Docket Item # 1  
BAR CASE # 2011-0091

BAR Meeting  
May 18, 2011

**ISSUE:** Garden Wall  
**APPLICANT:** James & Kelly Wilmeth  
**LOCATION:** 716 Gibbon Street  
**ZONE:** RB / Residential

Figure 9: Proposed plat

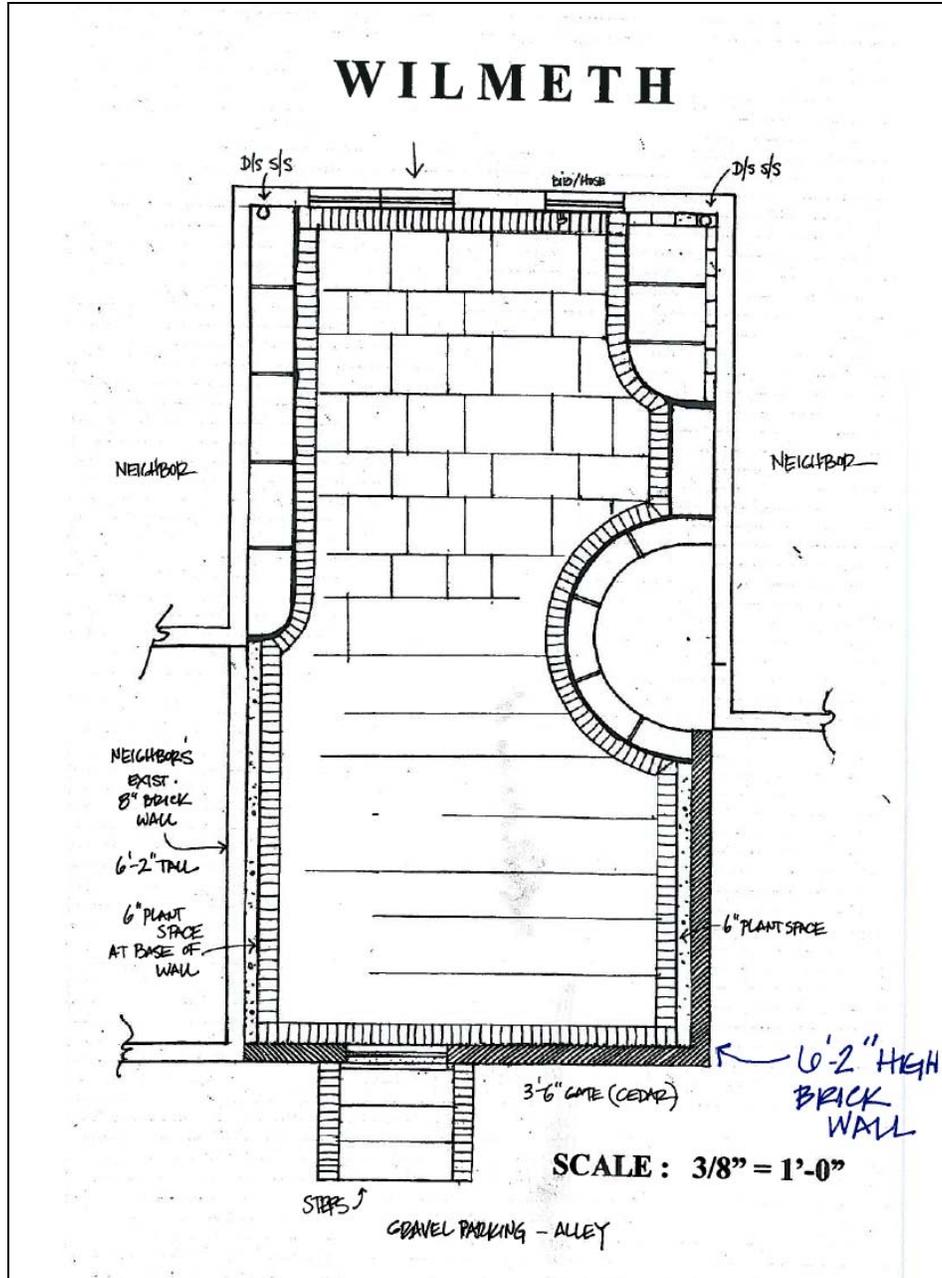
C-2 Clearly identify on the site plan length of existing fence and proposed masonry fence.

Figure 10: Proposed elevation of brick wall and wood gate as seen from inside the patio at 716 Gibbon.

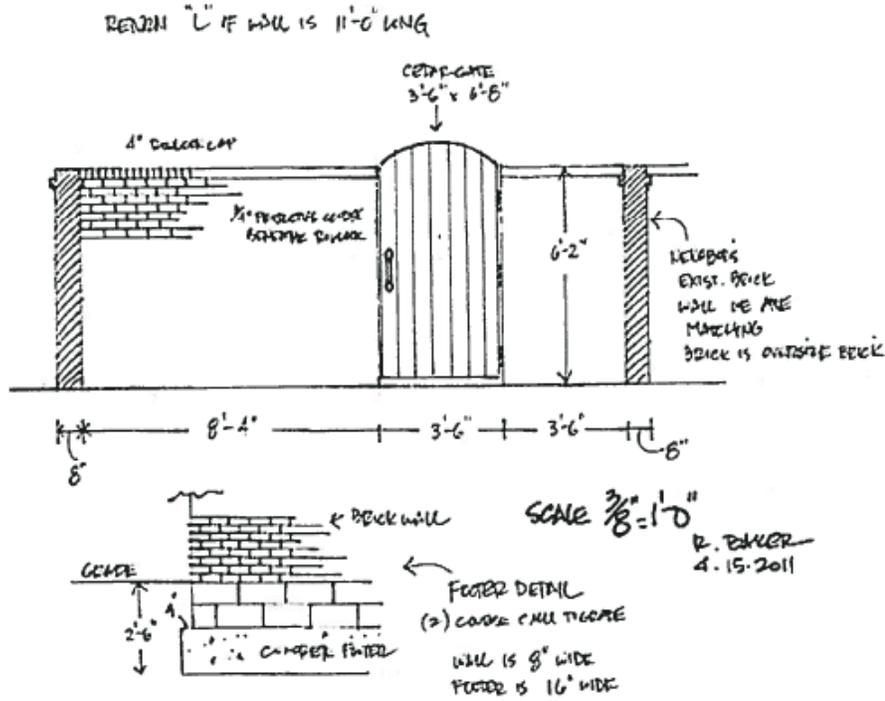
**STAFF RECOMMENDATION:** Staff recommends approval of the Certificate of Appropriateness application with the condition that the new gate is painted or stained.
